# UNITED STATES PATENT AND TRADEMARK OFFICE

APPLICATION NO.	FILING DATE	FIRST NAMED INVENTOR	ATTORNEY DOCKET NO.	CONFIRMATION NO.
10/009,696	11/06/2001	John Eric Arnold	DN1999111USA	1392
27280	7590	09/02/2005	EXAMINER	
THE GOODYEAR TIRE & RUBBER COMPANY INTELLECTUAL PROPERTY DEPARTMENT 823 1144 EAST MARKET STREET AKRON, OH 44316-0001			NGUYEN, XUAN LAN T	
			ART UNIT	PAPER NUMBER
			3683

<b>Office Action Summary</b>	<b>Application No.</b> 10/009,696	<b>Applicant(s)</b> ARNOLD ET AL.	
	<b>Examiner</b> Lan Nguyen	<b>Art Unit</b> 3683

## DETAILED ACTION

FIG. 4

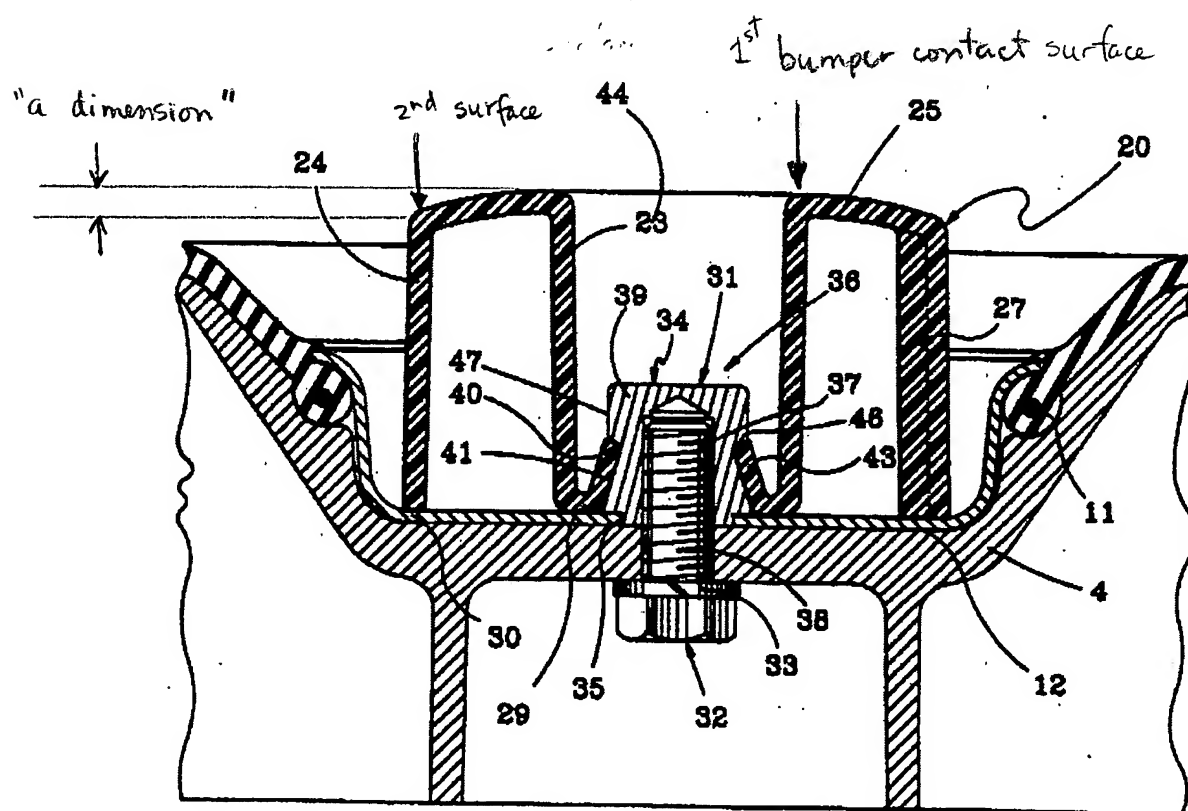
and at the opposing end to other retainer as shown, the improvement being characterized by: one of the retainers 12, 20 having a bumper-contact surface, please see the marked up figure below, within the sleeve 10 for axial movement into the sleeve, the bumper-contact surface formed as a part of the retainer 12, 20 and which contacts the other retainer when the air spring is collapsed, and absorbs and transmits forces generated from such contact, the bumper contact surface being centrally located on the surface of the retainer which extends into the sleeve during axial movement into the sleeve.

Re: claim 5, Ecktmann shows the first contact surface to be closer to the center corresponds to rib 29, the second contact surface to be further out corresponds to rib 30 and are separated by a dimension, please see the marked up figure above.

Re: claim 18, Ecktman shows the retainer 12, 20 extends into the chamber 15 and the axially outer surface to be closer to the center corresponds to rib 29, a separate axially outer surface to be further out corresponds to rib 30 and are separated by a dimension, see marked up figure above.
